ADDENDUM NO. B

Colton MS Administration Modernization & New Locker Room Building – DSA App #04-123792)

Colton MS Pavillion – DSA App #04-123039

Colton Joint Unified School District
1212 Valencia Drive
Colton, CA 92324

1 ELECTRICAL - ADMIN BLDG ROOF PLAN - DEMOLITION
1/8" = 1'-0"

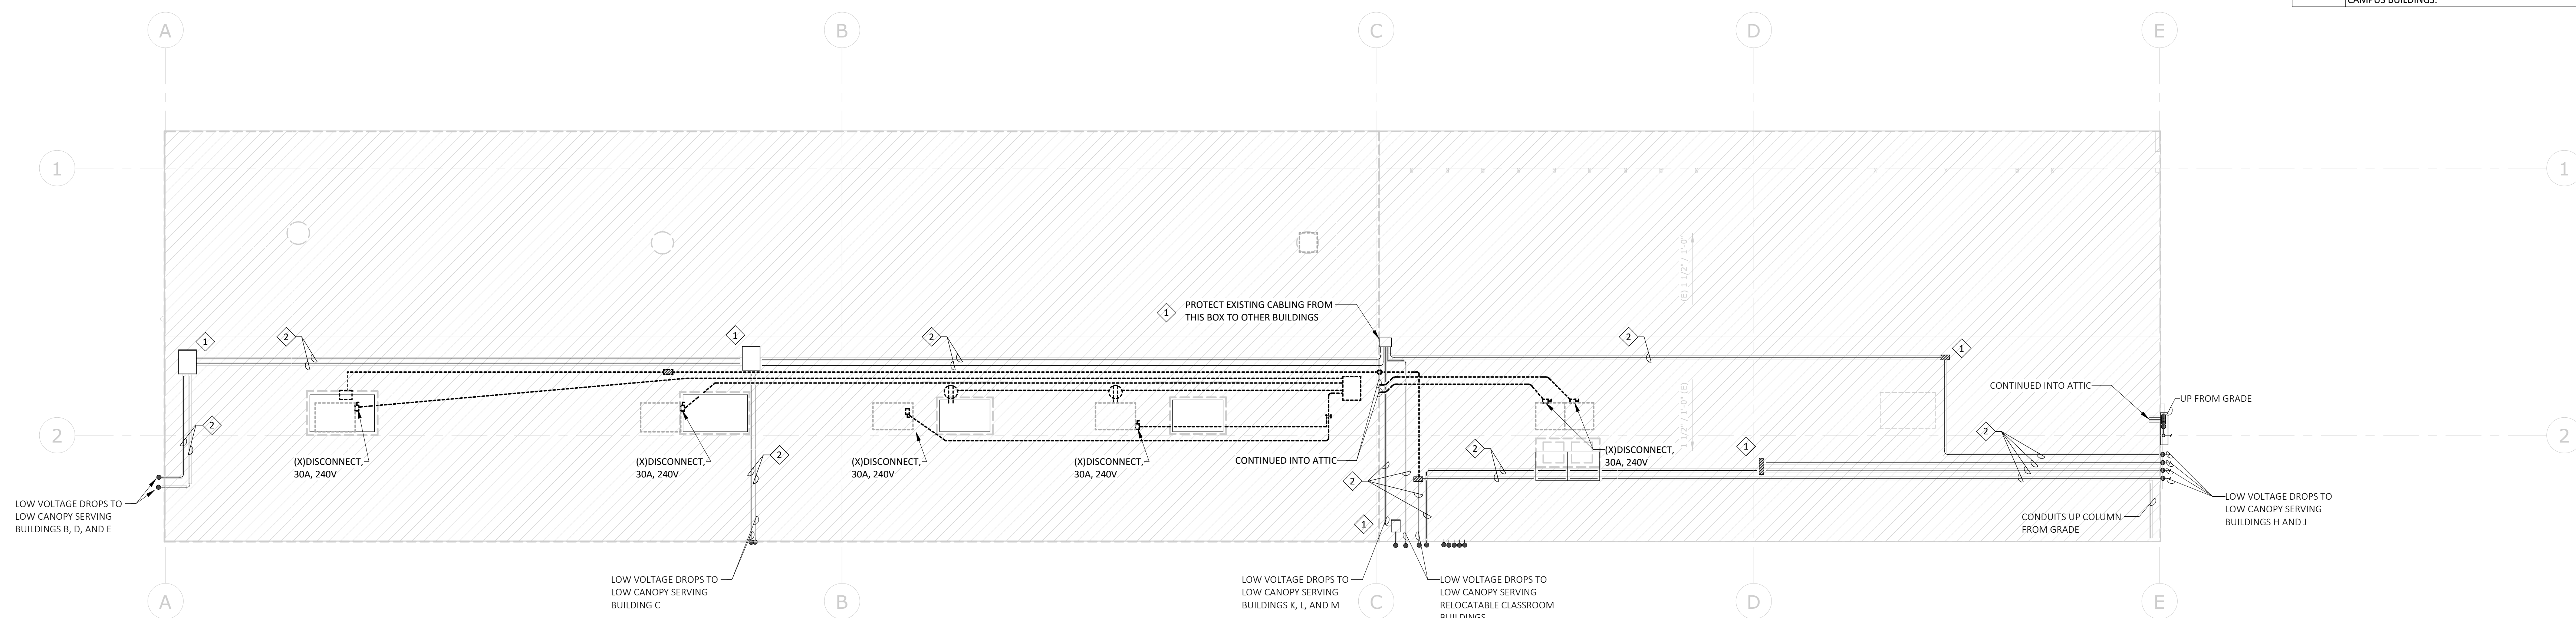
- Item No. B.35 Reference Sheet E1-2.0 – Electrical - Admin Bldg Roof Plan – Demolition:
 - B.35.1 Revised per clouded areas of attached sheet and items listed below.
 - a) Revised keynote 2 to reference detail 10/E-4.1 for roof conduit attachment.
- Item No. B.36 Reference Sheet E1-2.1 - Electrical - Admin Bldg Roof Plan – Remodel:
 - B.36.1 Revised per clouded areas of attached sheet and items listed below.
 - a) Revised keynote 3 to reference detail 10/E-4.1 for roof conduit attachment.
- Item No. B.37 Reference Sheet E-4.1 - Electrical Details:
 - B.37.1 Revised per clouded areas of attached sheet and items listed below.
 - a) Added details 10 and 11 in their entirety.
- Item No. B.38 Reference Sheet E-4.2 – Electrical – Site Plan – Remodel – Photometrics:
 - B.38.1 Revised per clouded areas of attached sheet and items listed below.
 - a) Added EEOR stamp to drawing.

1 TECHNOLOGY - ADMIN BLDG FLOOR PLAN - REMODEL
1/8" = 1'-0"

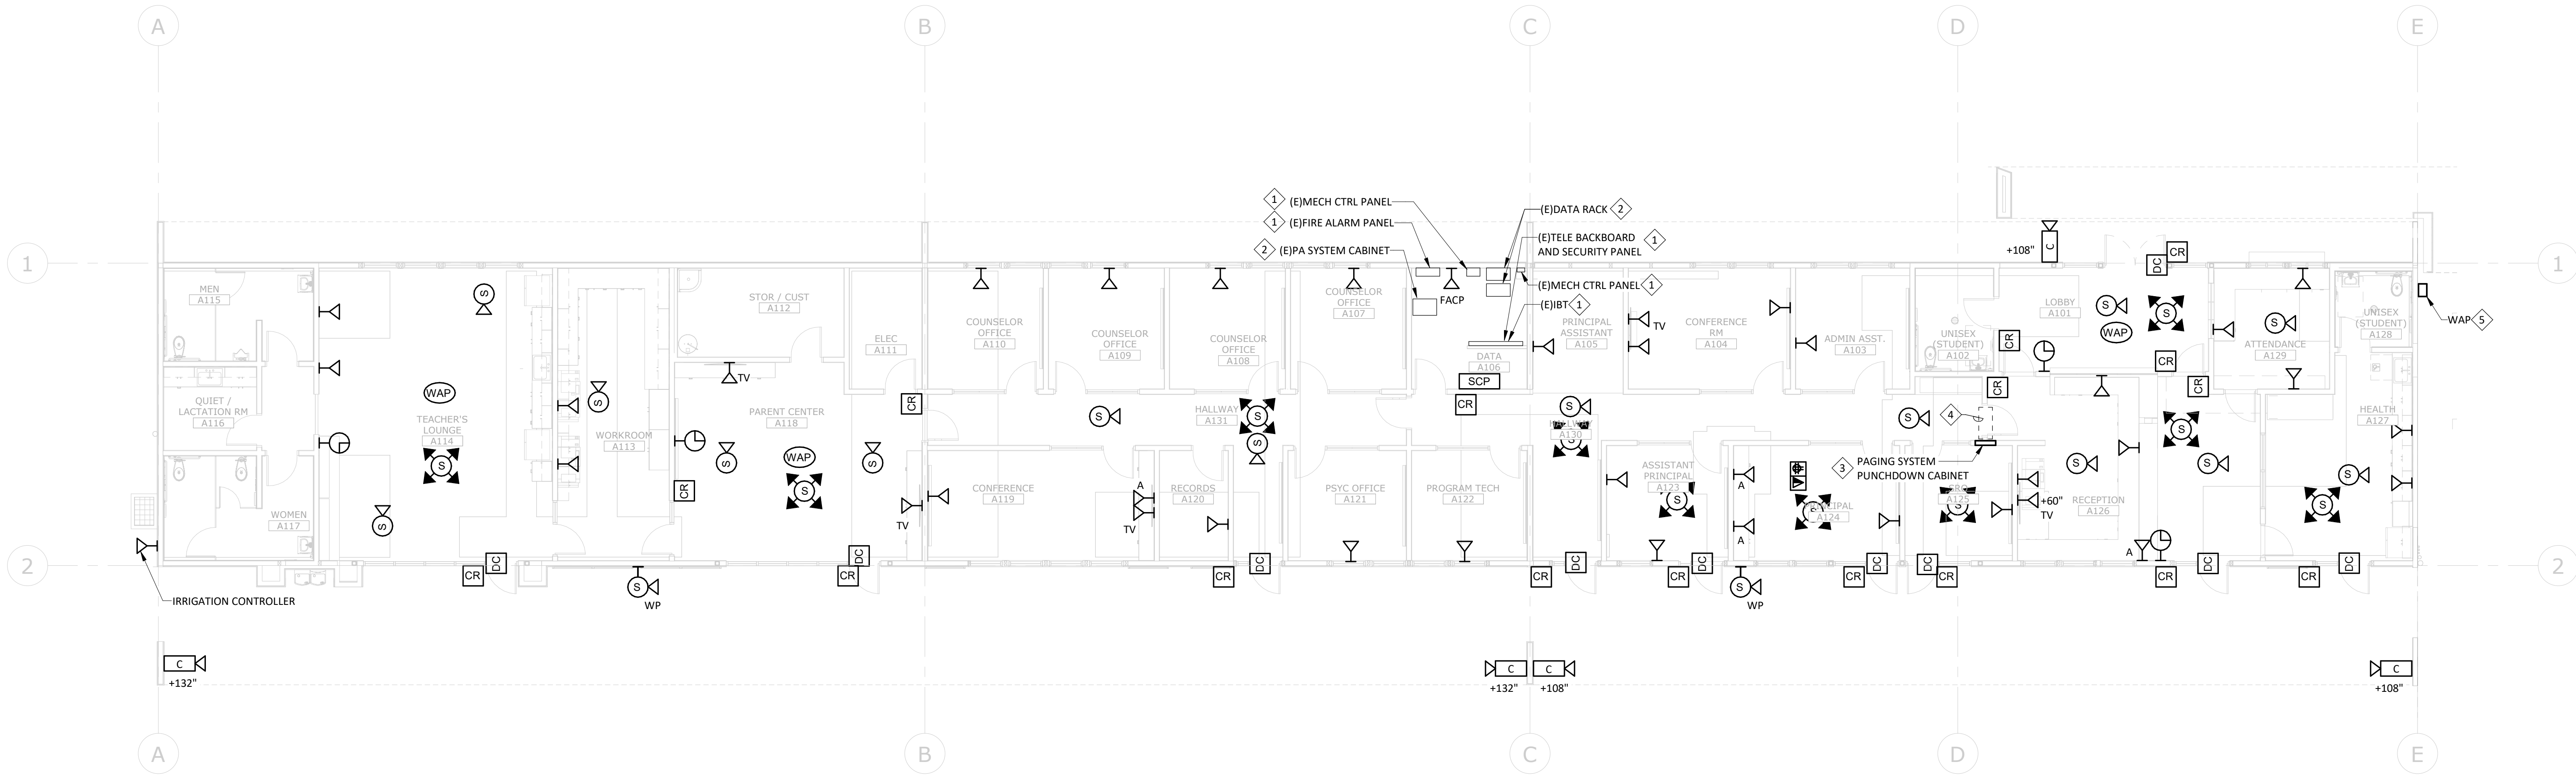
- Item No. B.41 Reference Sheet T1-1.1 – Technology – Admin Bldg Floor Plan – Remodel:
 - B.41.1 Revised per clouded areas of attached sheet and items listed below.
 - a) Revise keynote 2 to indicate protection in place of existing data racks and paging system cabinet.
 - b) Revise keynote 3 to include reference to detail 11/E-4.1 for recessed cabinet mounting.
